ANCHORAGE WATERWAYS COUNCIL

June 22, 2010

Re: Permit No. 10-SOL-01 issued April 30, 2010

Fig. 2 MPF 5 There is no orientation to this map, although it is probably West at the top. Where is land, water, snow, road, railroad, vegetation? What is the double line?

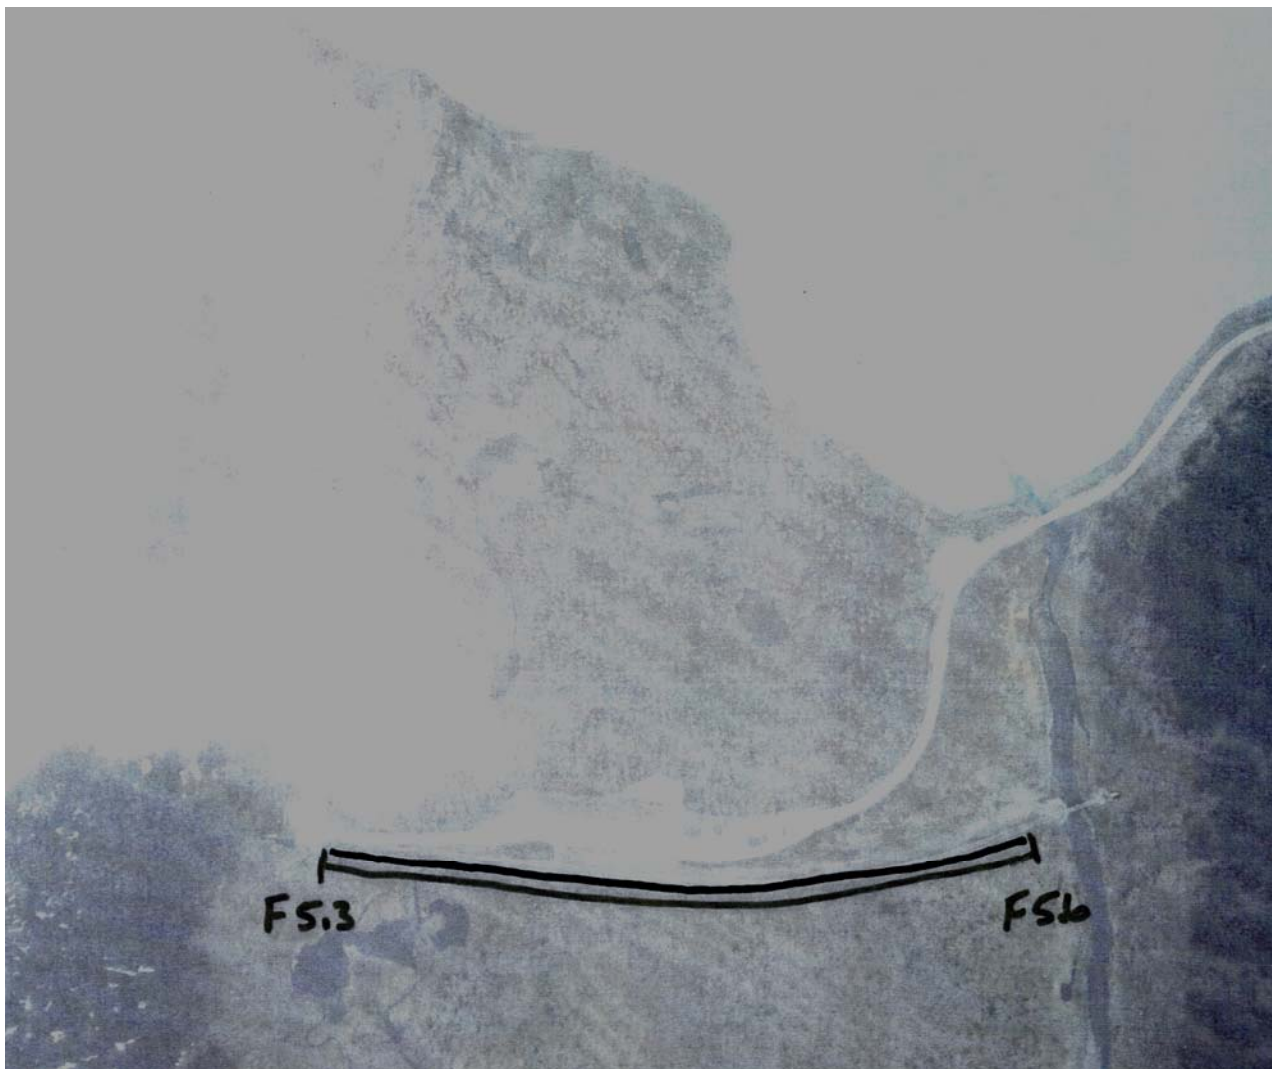
With no scale, it was impossible to make any judgments as to their proximity to water bodies, nor were any of the water bodies, i.e. Turnagain Arm, labeled. The quality of some of the “maps” was so degraded that it was impossible to tell land from water from snow. A couple of the best examples are “maps” MPF 5 (following) and MP 19.

Fig. 3 MP 19

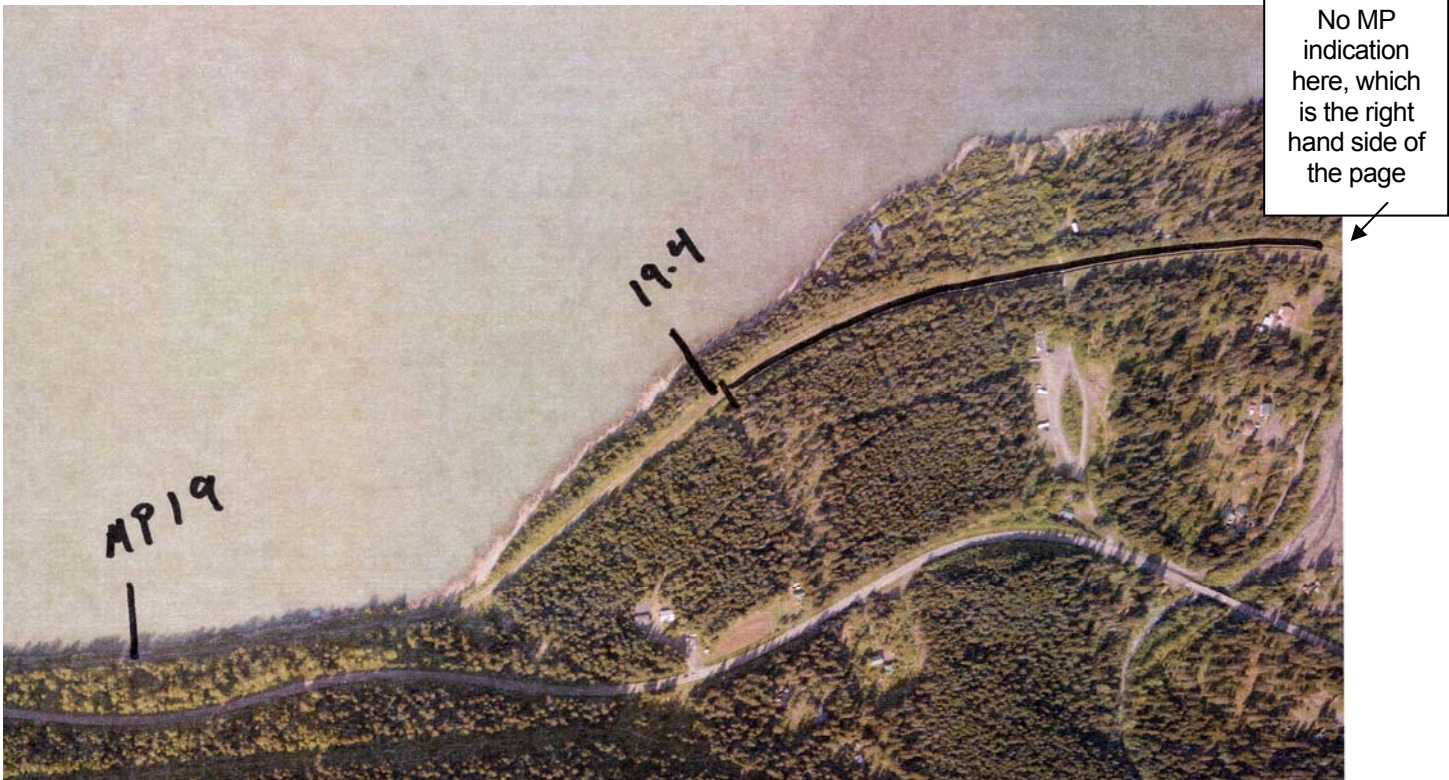
Ms. Hendrickson assured me that the “maps” were tied to the tables on pp. 2-3 of the Decision Document, yet I found errors in the table. On the “maps” for MP 19 and 20, the table states that the spraying area runs from MP 19.4 to 20.3 without a break.

Yet, on the MP “maps”, the black hand-drawn line runs from “19.4” on MP 19 to the edge of the paper, stops without any indication as to what this ending MP distance is, starts up again, without any indication as to the starting point on MP 20’s left edge, ends at an unnamed point by an unnamed river, and begins again at “20.1” until “20.3”. This is illustrated in the two photo excerpts below. And, one extrapolation that can be drawn from this is that the numbers in the table are incorrect. I did not check all of them, but this mistake makes me uncomfortable with accepting the figures provided by ARRC. There does not seem to be the attention to detail in this area, which makes other promises and commitments questionable.
